Wood Duck Solar LLC
Responses to Siting Board Staff's Second Request for Information
Case No. 2024-00337

Wood Duck Solar LLC
Responses to Siting Board Staff's Second Request for Information
Case No. 2024-00337

Participating and Non Participating
Parcels

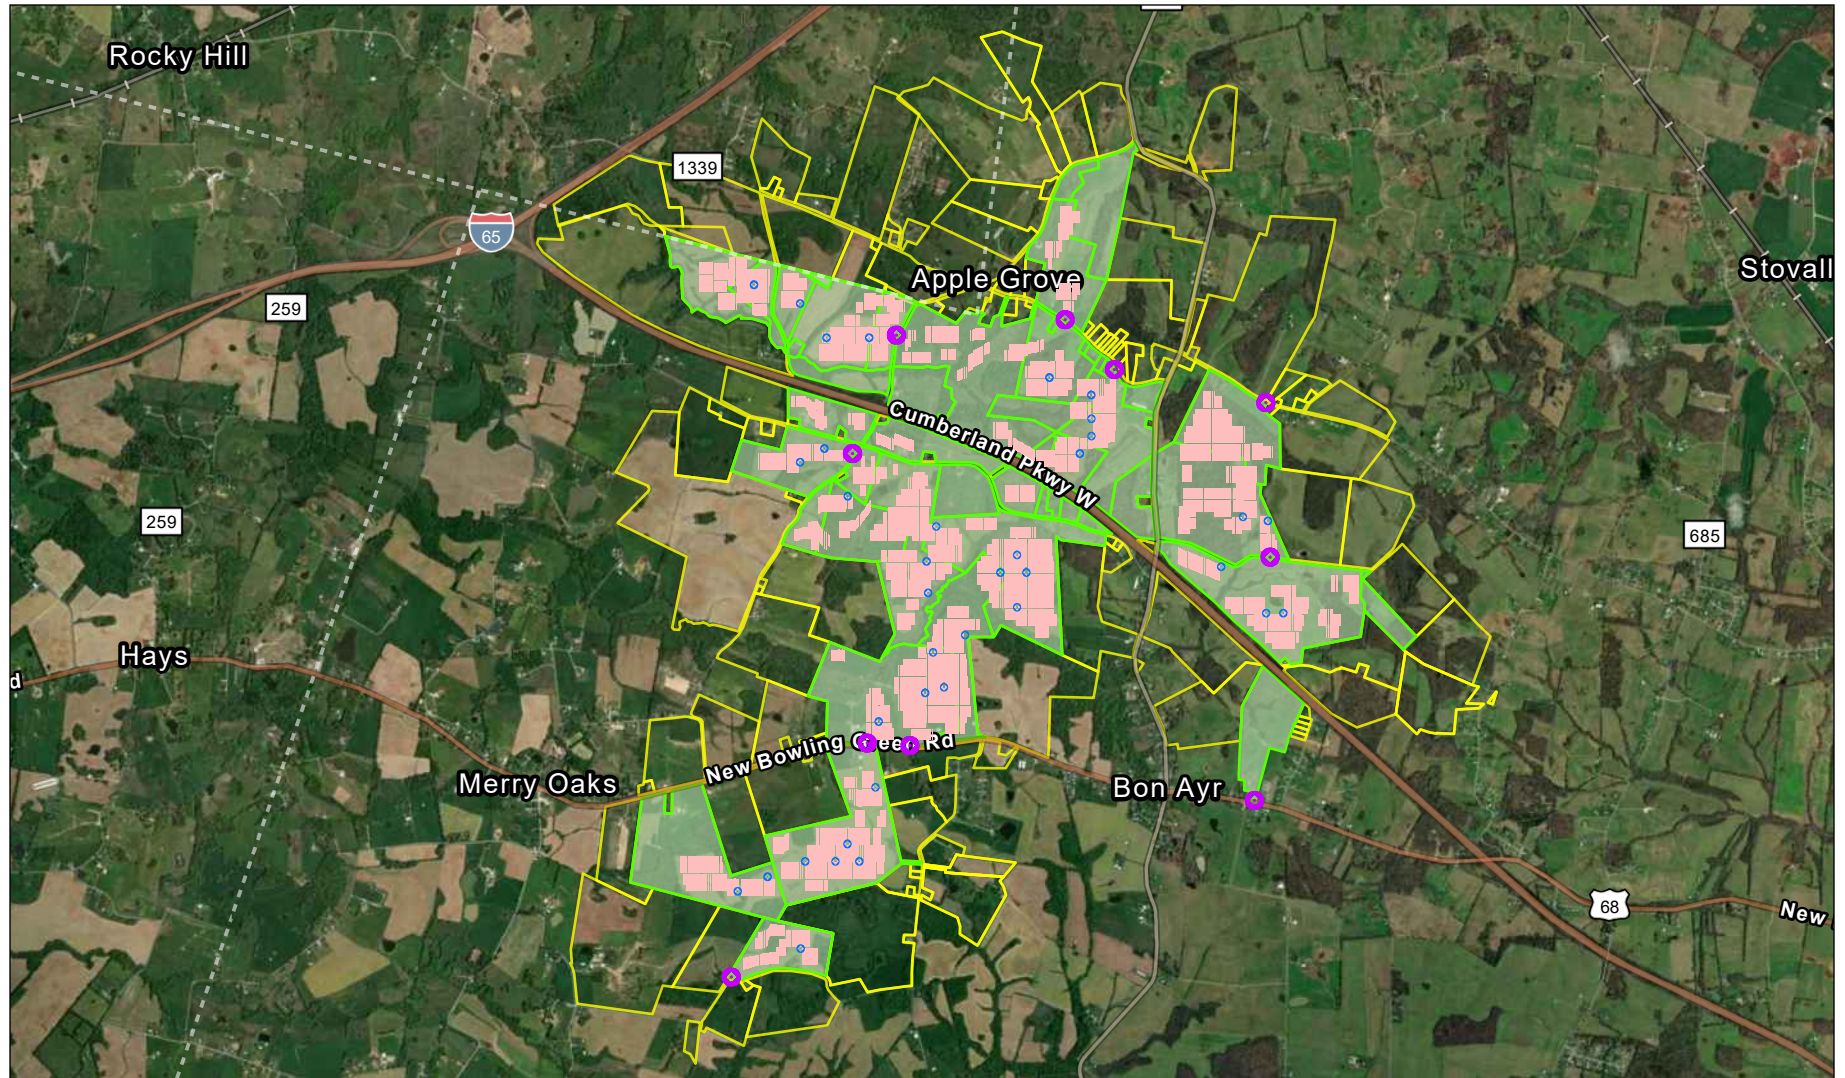
Provide an updated map identifying all participating and non-participating parcels. Include in the map: proposed solar array areas, proposed access points, and proposed inverter locations.

See attached.

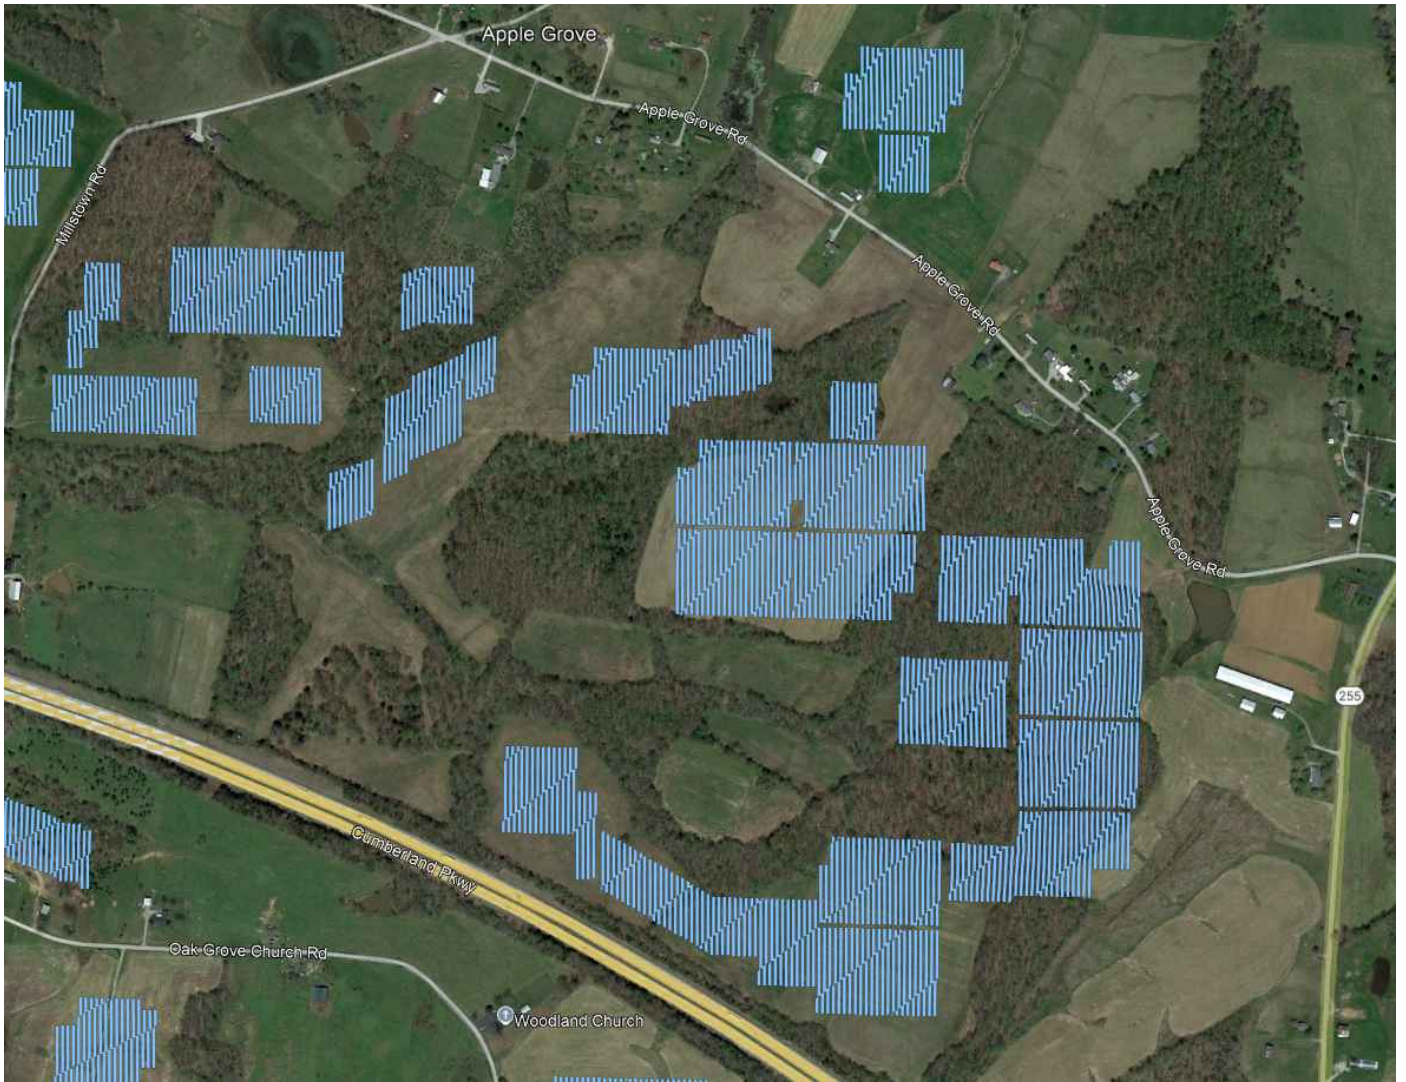
Refer to the public comment 20250724_Response E-Mail to Gwynne Aidala.pdf filed on July 24, 2025, pages 3-4. Confirm whether the images accurately depict vegetative clearing on the Project site. If confirmed, explain whether such vegetative clearing has altered Wood Duck Solar's prior estimate of a maximum of 223 acres of vegetative clearing provided in response to Siting Board Staff's First Request for Information (Staff's First Request), Item 27.

Please see the attached aerial images from Google Earth depicts the tree clearing activity between April 2022 and April 2025 with respect to the area in question. This tree clearing activity was not at the request of the Project and was voluntarily completed by the landowner. Because this tree clearing was not undertaken by the Project, there is not a definitive response as to how many acres of the original 223 acres were affected. In turn, although the precise acreage is not known, the Project will be clearing less than 223 acres.

Cultural Resources Near Project

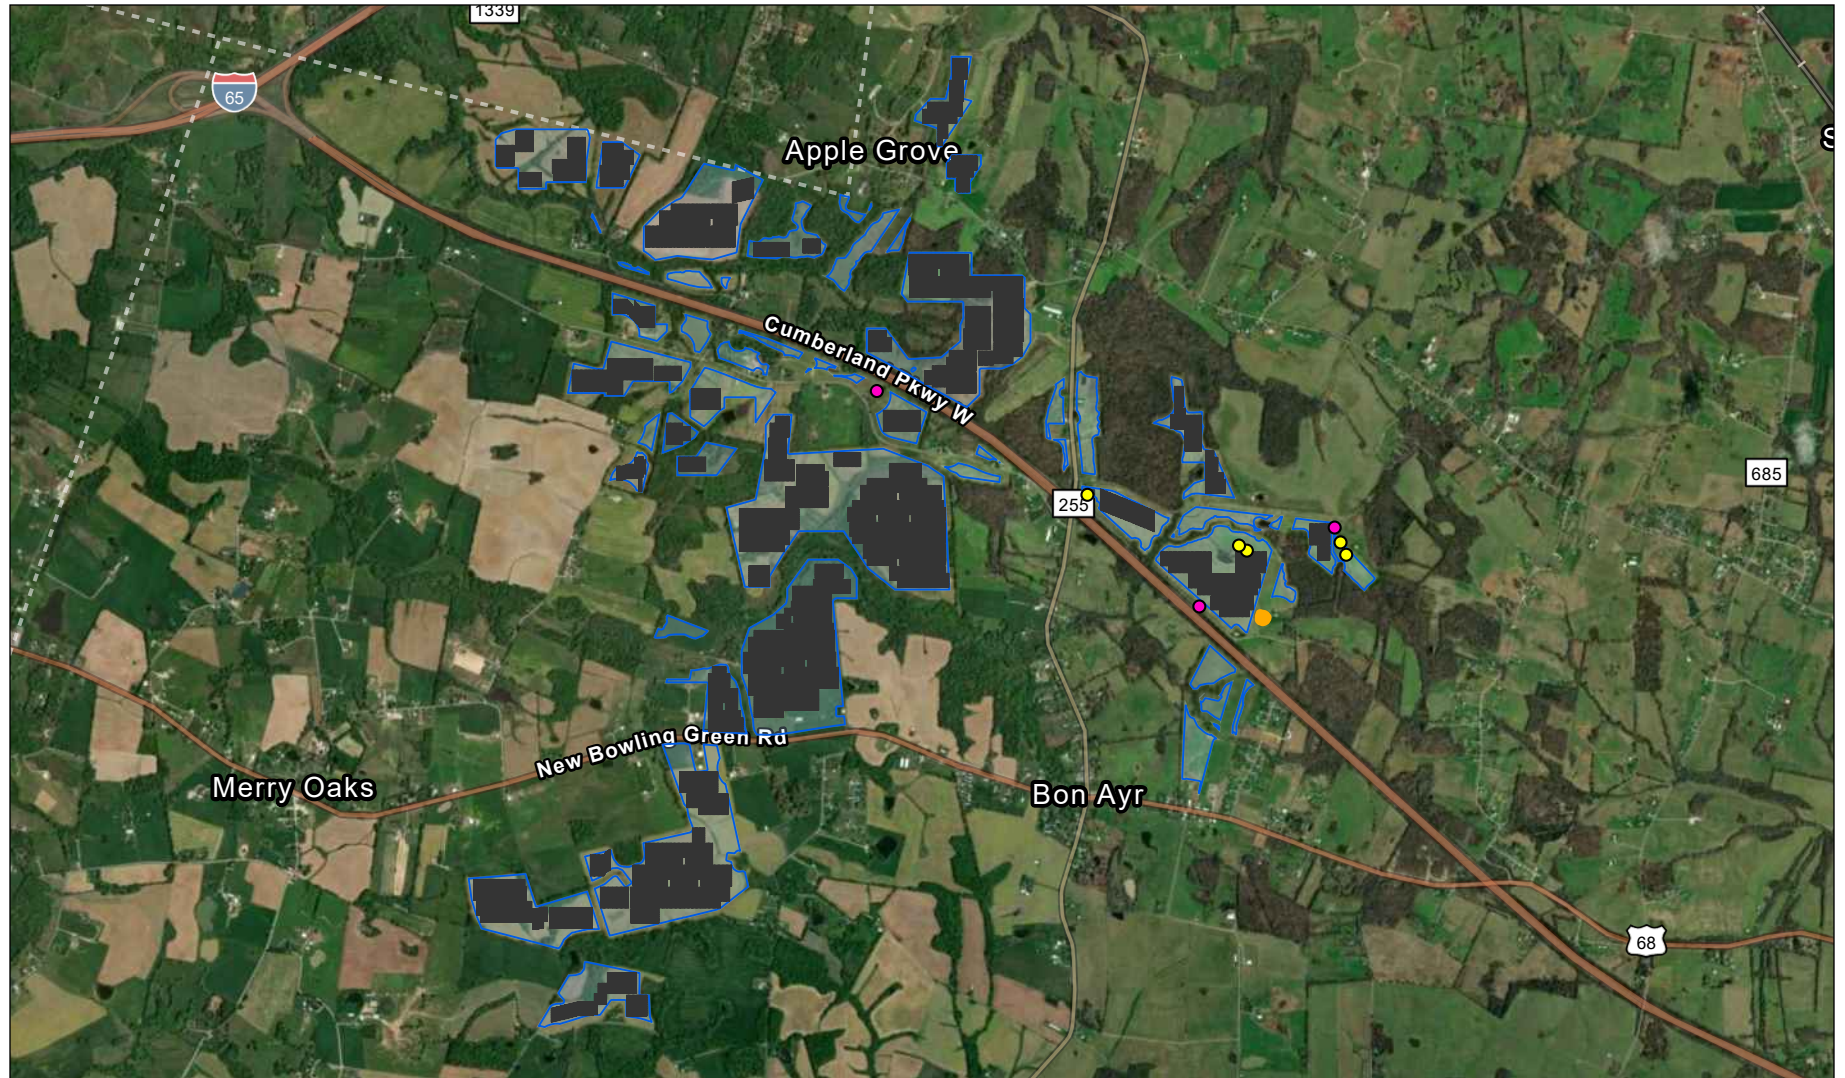
Refer to Wood Duck Solar's response to Staff's First Request, Item 33, Attachment part 3, page 542. Provide a map depicting the locations of the archaeological site, the three historic structures, and the three historic cemeteries. Include on the map, proposed solar array areas and proposed setbacks.

See attached.

Title
Active Agriculture Areas

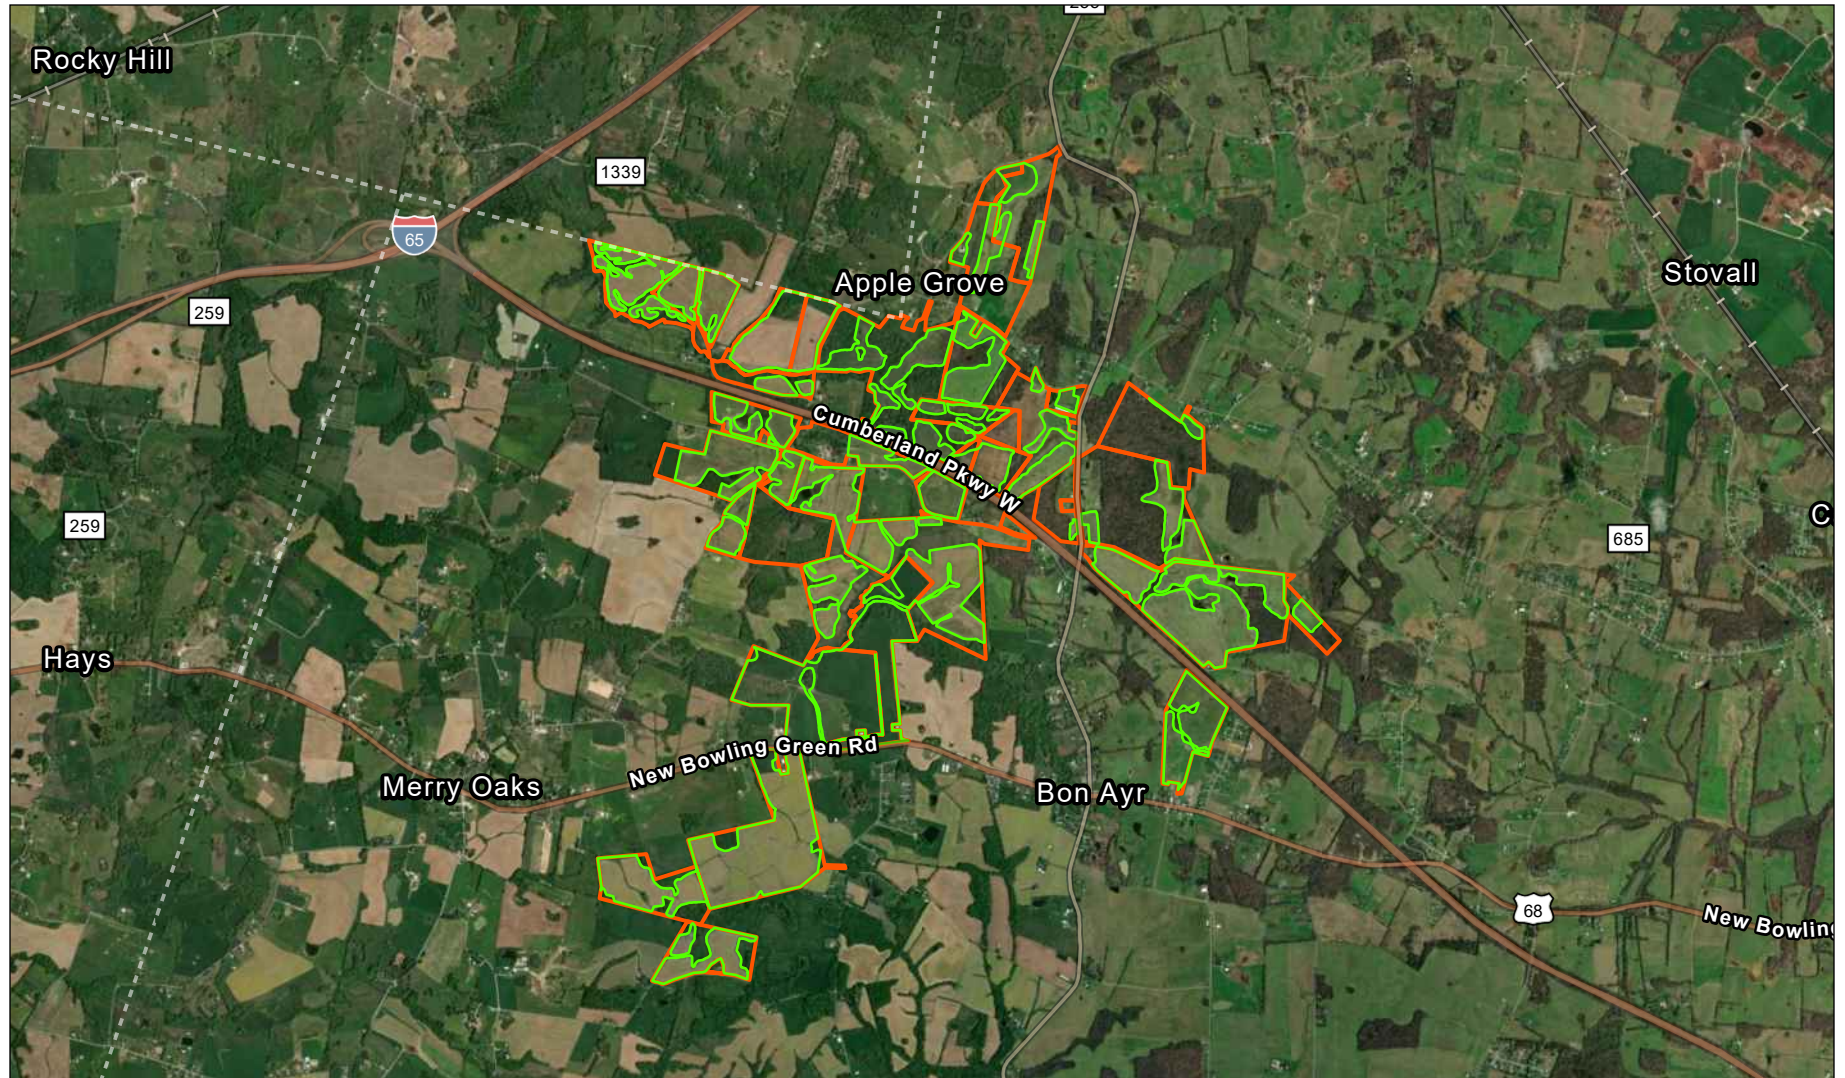
Provide the total acreage of the 2,259-acre proposed Project site that is currently being used for active agricultural production.

See attached for a Project map depicting active agricultural areas. Stantec reviewed recent aerial imagery and delineated areas that appear to be in active agricultural production. Approximately 1,256.6 acres were mapped as being potentially used for active agriculture.
